6.0 ADMINISTRATIVE CONTROLS

SAFETY EVALUATION

TURKEY POINT SPEC
5/25/82

FIGURE 6.2-1 OFFSITE ORGANIZATION FOR FACILITY MANAGEMENT AND TECHNICAL SUPPORT

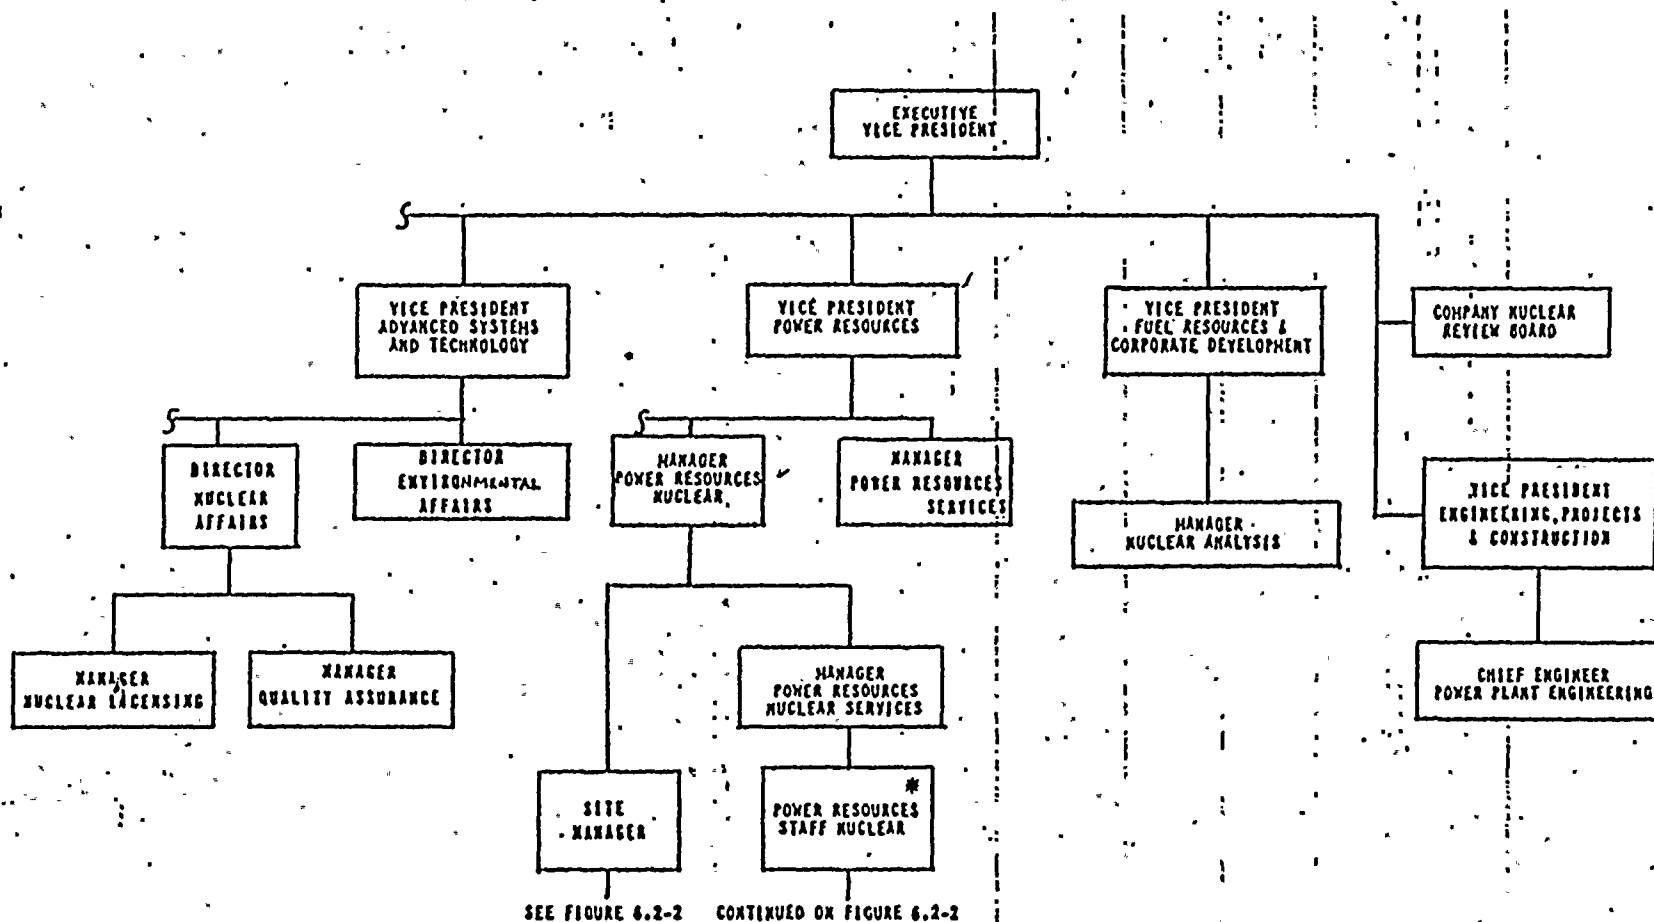
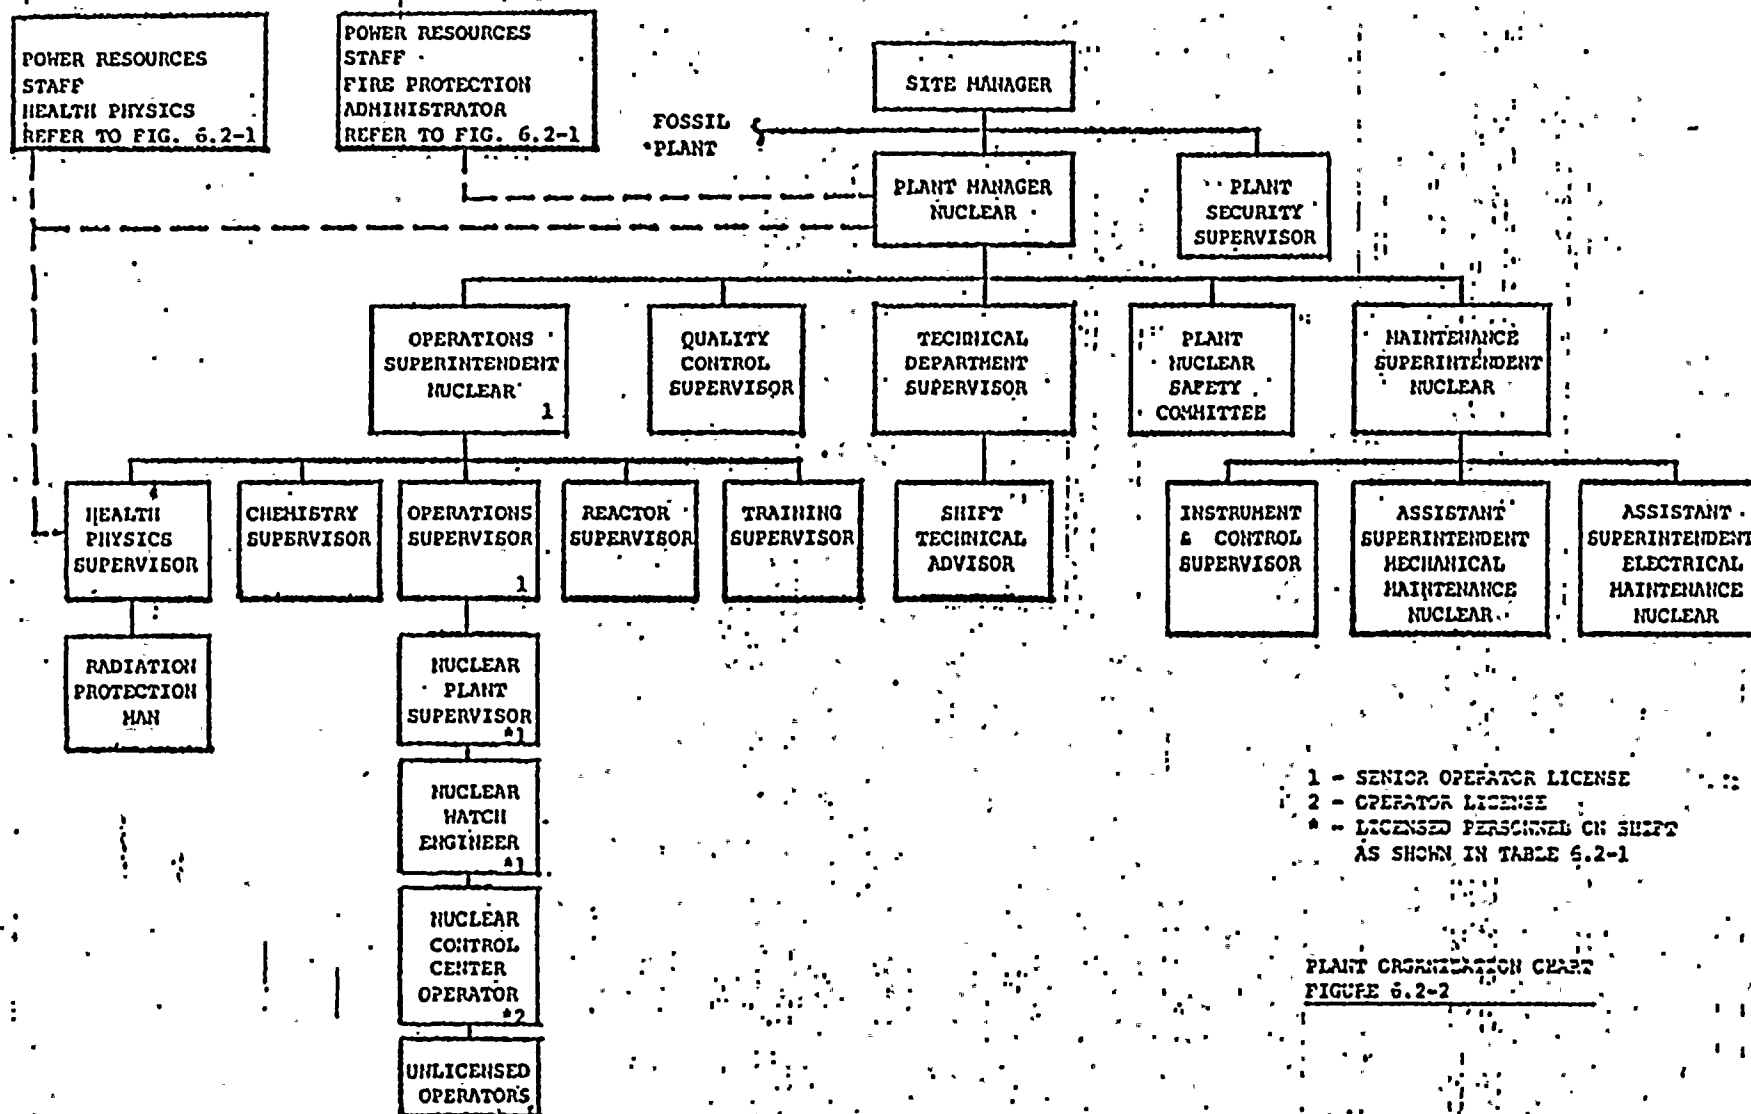
There are no safety related effects connected with the removal of the offsite management and technical support description and organization charts from the Technical Specifications. The purpose of including these descriptions is for general information and the corporate structure to those in possession of the Technical Specifications. However, this same information is also contained in the Florida Power & Light Company Topical Quality Assurance report (FPLTQAR).

We supply controlled copies of the FPLTQAR to at least the same non-FPL organizations as receive controlled copies of the Technical Specifications. The FPLTQAR is required to be updated to reflect all changes to the organization which affect quality within 30 days by letter and one year by amendment. It is our opinion that duplication of material between the two documents is unnecessary and that processing the same change twice is an unneeded burden on the time and manpower resources of both FPL and the NRC. Should the need arise for information on the organization, the FPLTQAR will be available to the same people who previously would have had the organizational description in the Technical Specifications.

- 6.2.1 The offsite organization for facility management and technical support shall be as shown in Appendix A of the Florida Power and Light Company Topical Quality Assurance Report.
